CODE CHANGES RESOURCE COLLECTION: 2009 IBC[®]

APPROVED CODE CHANGES RESULTING IN THE 2009 IBC[®]

Publication Date: March 2009

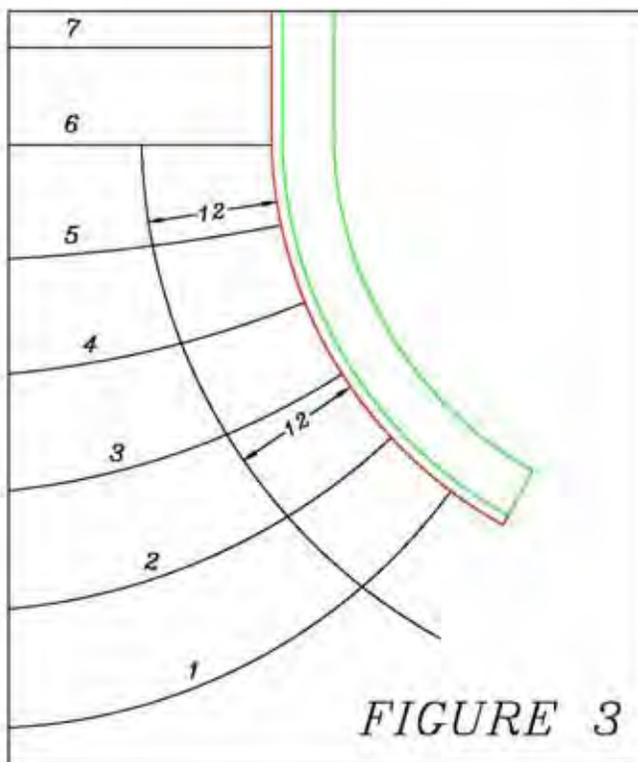
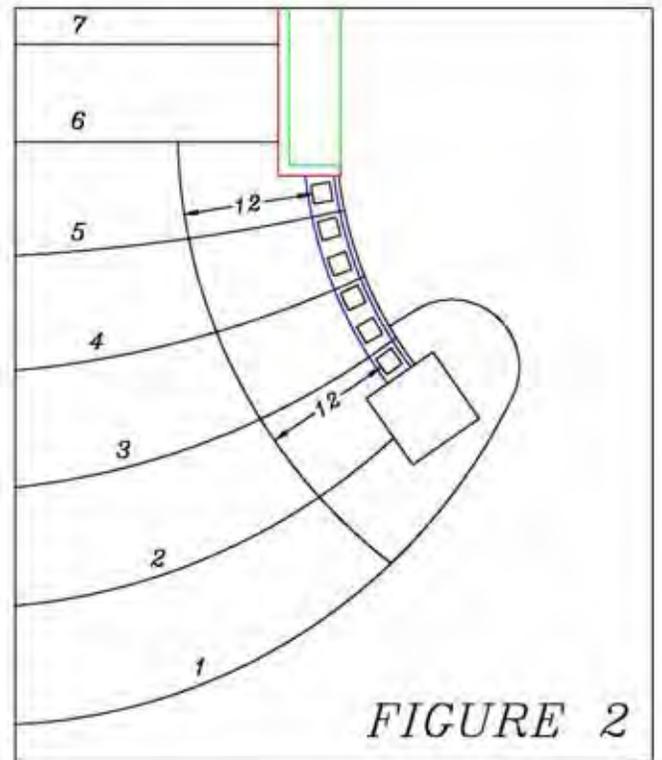
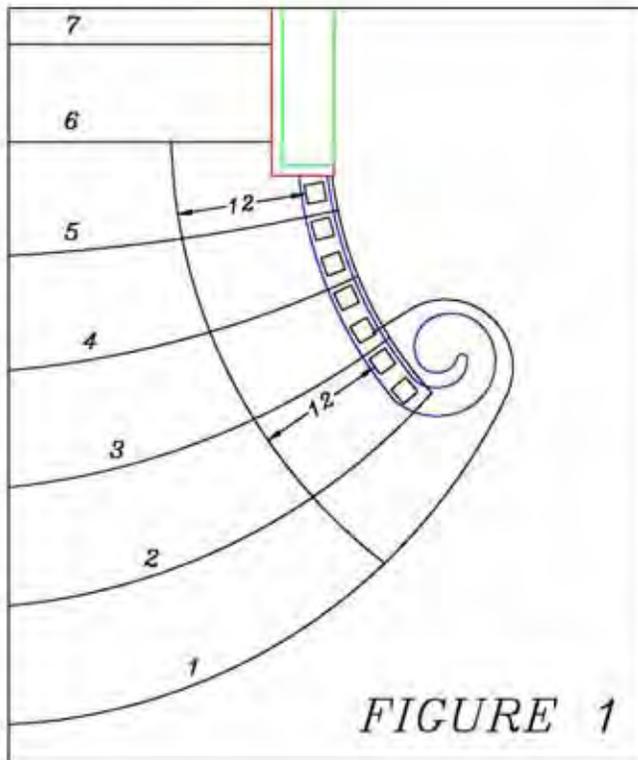
The IRC committee had issues with the terminology "used for placement of the foot..." and that has been stricken. The new section titled walk line states clearly and specifically how to locate the walk line at winder treads where it is used to determine the tread depth of winder tread(s) that provide for turning of the stair's direction of travel. This line of travel across winders is a curved path and the walk line established for regulation must parallel it. The term concentric is used because it more accurately describes the geometry of parallel arcs or curves sharing the same center. This separate section substantiates this essential element required in the design and construction of stairs that turn. It further provides clarity for regulating its location that is not subject to the wide interpretation of the present code and thereby allows for the direct reference to walk line in subsequent sections of the code. Please also see the original supporting statement for further substantiation of these changes.

The simple steps to determine compliance are:

Locate the winder treads in the turn of the stair.

1. Locate the side of the stair where the winder treads are narrower
2. Establish the widest point of clear width of the stair at the surface of the winder or run of adjacent winders
3. Measure across the stair width 12 inches from the object that restricts the clear width at the tread surface
4. Measure tread depth between the intersections of the nosings with the walk line.

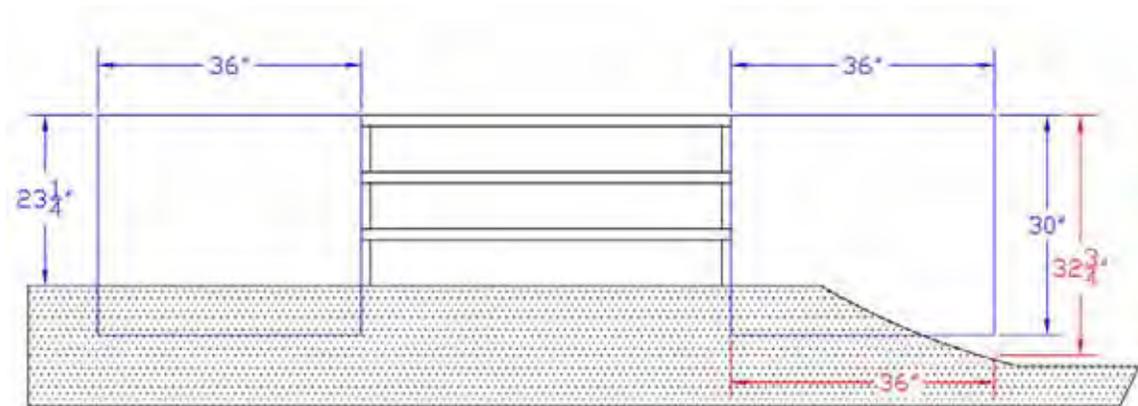
IBC 1013.1. Laundry lists of items in the code are typically not all-inclusive. The word "including" provides this clarification in the following sections as well. This section is divided into two paragraphs with the second paragraph dealing with glass and glazing without a change in intent.

The key part of this change to IBC 1013.1 is submitted in order to clarify how the height measurement which triggers the guard requirement is made relative to the adjacent fall-off. This is illustrated in the following figure:

The view is taken from the landing of a 3 riser stair, looking towards the face of the risers.

**FIGURE 1805.3.1
FOUNDATION CLEARANCES FROM SLOPES**

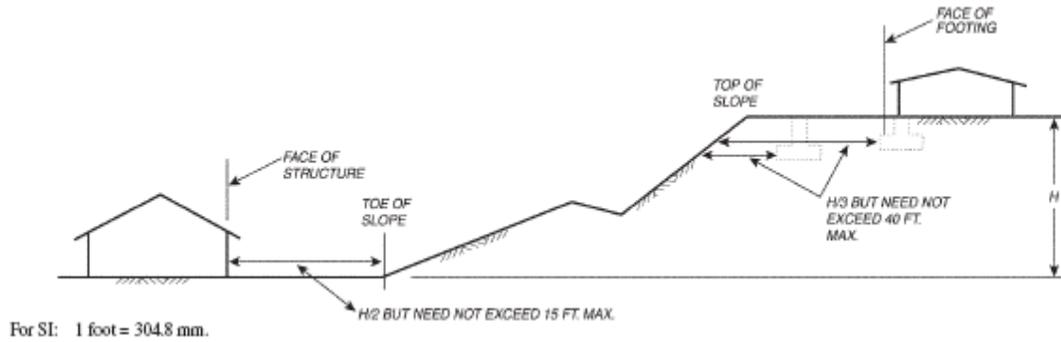
Revise figure notation as follows:

Reason: Code clarification. Editorial.

AT LEAST THE SMALLER OF H/2 AND BUT NEED NOT EXCEED 15 FEET FT. MAX
AT LEAST THE SMALLER OF H/3 AND BUT NEED NOT EXCEED 40 FEET FT. MAX

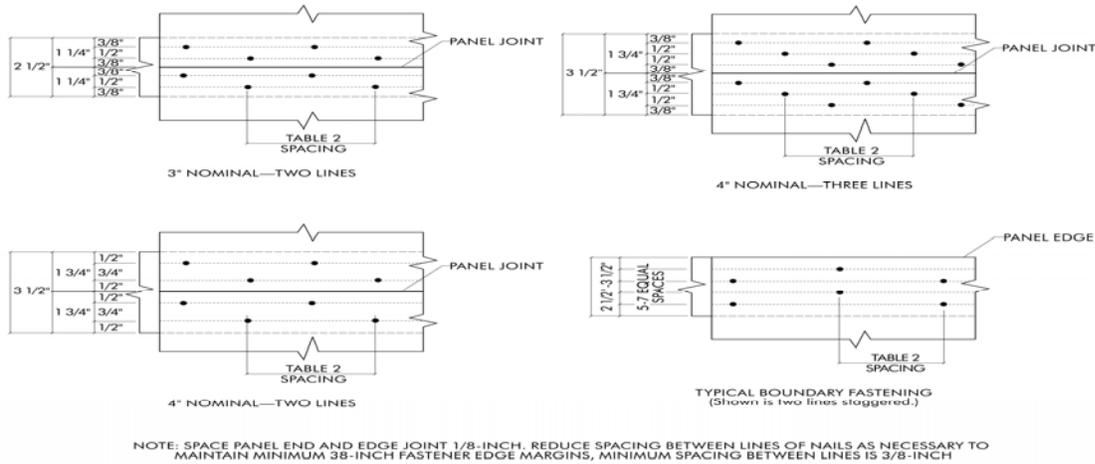
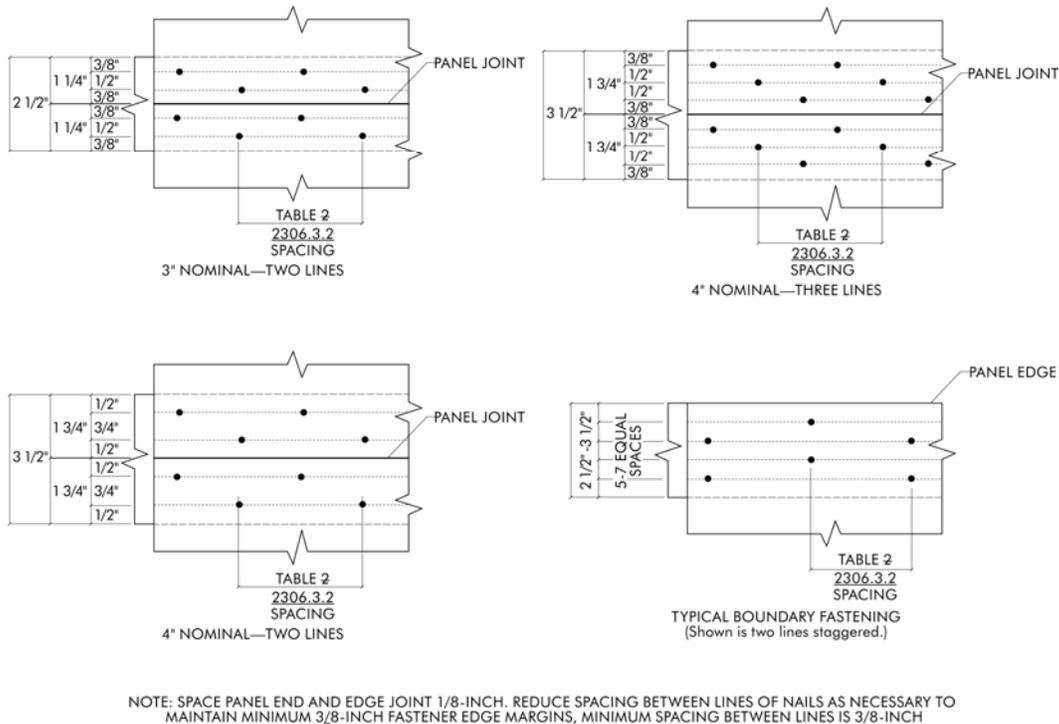
Reason: The purpose is to clarify the code.

When the table was added to the IBC, the figures at the bottom of the table were inadvertently left out. The figures give diagrams of the various multi-row nail applications showing required spacing and staggering. These construction details provide clarity to the table and are essential to develop the values listed in the table. These figures have been part of this table for over two decades.

Modify proposal as follows:

Committee Reason: This proposal clarifies the code by adding an illustration of nail spacing and staggering to the diaphragm load table. The modification corrects typos in the figure submitted with the code change.

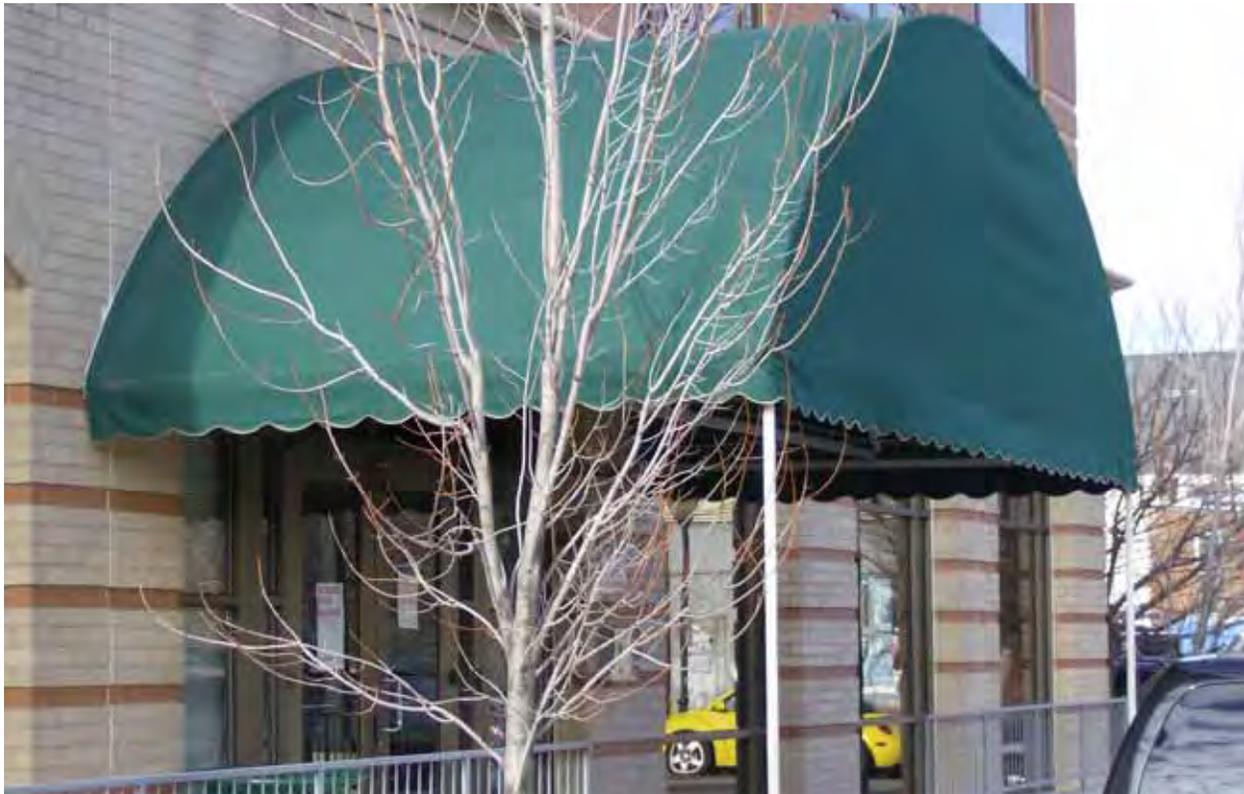
This photo fits the definition of a canopy, and at the same time, fits the building code definition of a tent:

The above photo is also addressed in the fire code as a canopy but it doesn't fit the fire code definition.
